Evaluation of proposed move for Water Right No. 14113

Proposed: Move water right no. 14113 to a new location 2,634 ft to the southeast.

WELL TEST ANALYSIS

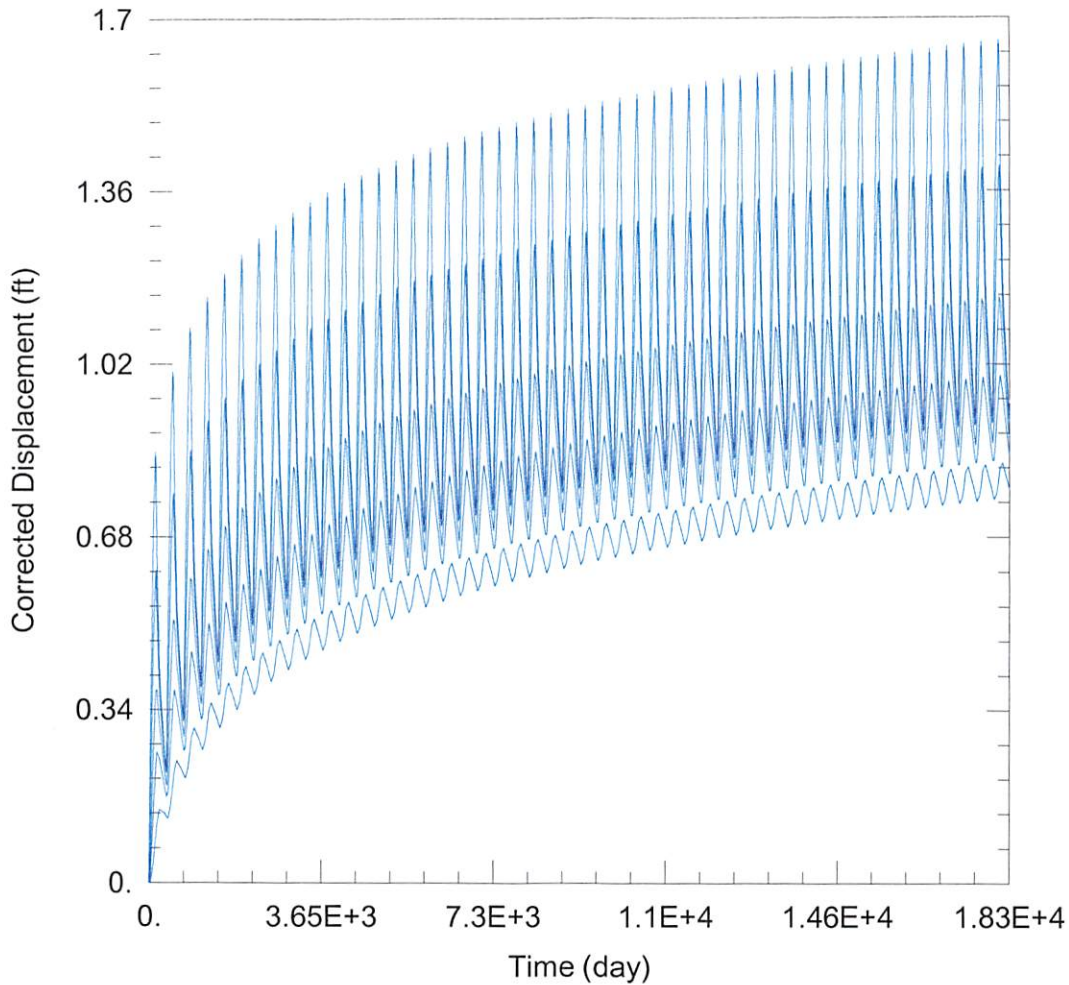
- 21720:
 - Drawdown from current location = 1.66 ft
 - Drawdown from proposed location = 3.68 ft
 - Net drawdown = **2.0 ft**
- 26897:
 - Drawdown from current location = 1.41 ft
 - Drawdown from proposed location = 4.39 ft
 - Net drawdown = **3.0 ft**

27145: Drawdown from current location = 1.15 ft
Drawdown from proposed location = 5.20 ft
Net drawdown = **4.1 ft**

11461: Drawdown from current location = 1.00 ft
Drawdown from proposed location = 3.67 ft
Net drawdown = **2.7 ft**

24599: Drawdown from current location = 0.83 ft
Drawdown from proposed location = 3.56 ft
Net drawdown = **2.7 ft**

Net drawdown exceeds the drawdown allowance of 4.0 ft for water right number 27145. Critical well analysis was performed for that well.

The proposal is unlikely to cause noticeable effects on most neighboring wells. There is potential for one neighboring well, 27145, to experience well to well interaction effects slightly exceeding 4 ft, but based on modeled aquifer characteristics, this well is not critical and is unlikely to be unreasonably impaired. GMD3 staff recommends approval of this application.
